AMENDMENTS TO THE SUBSTITUTE SPECIFICATION:

AMENDMENTS TO THE DRAWINGS:

FIG.4

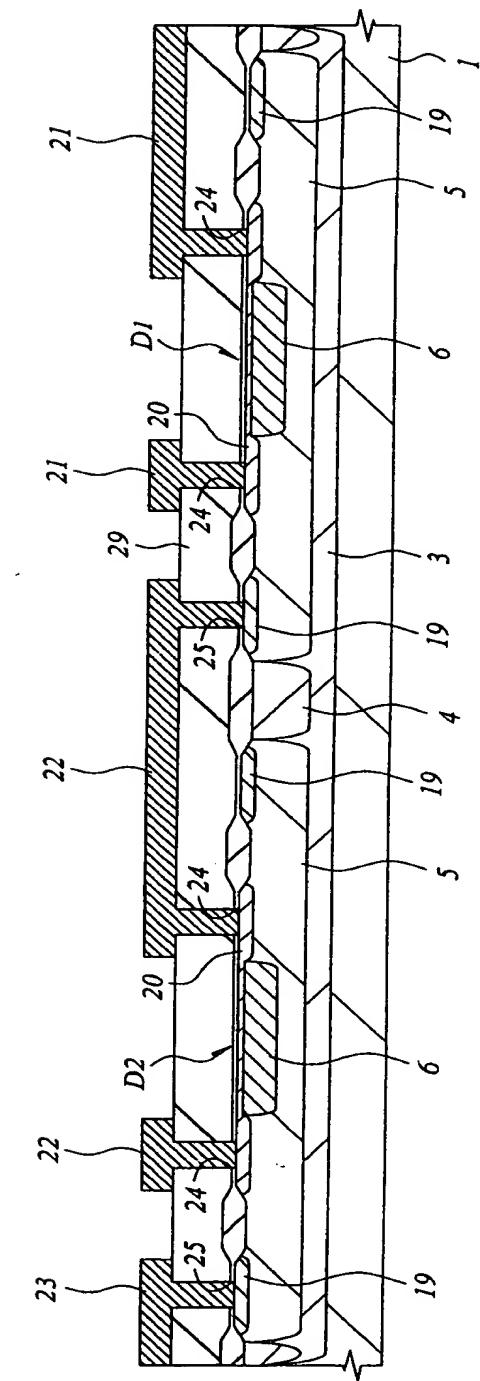
The attached sheet of drawings includes the earlier approved changes to Fig. 4. This sheet, which includes Fig. 4, replaces the originally submitted drawing sheet of that Figure. In Fig. 4 a labeling correction of the third contact hole from the left in that Figure was effected.

The accompanying replacement sheet of drawings directed to Fig. 4 thereof formally includes the earlier revision proposed in the paper submitted on January 21, 2003, which was approved for entry in form PTO-326 in connection with the Final Office Action dated April 8, 2003. Acceptance and formal entry therefor of the same is respectfully requested.
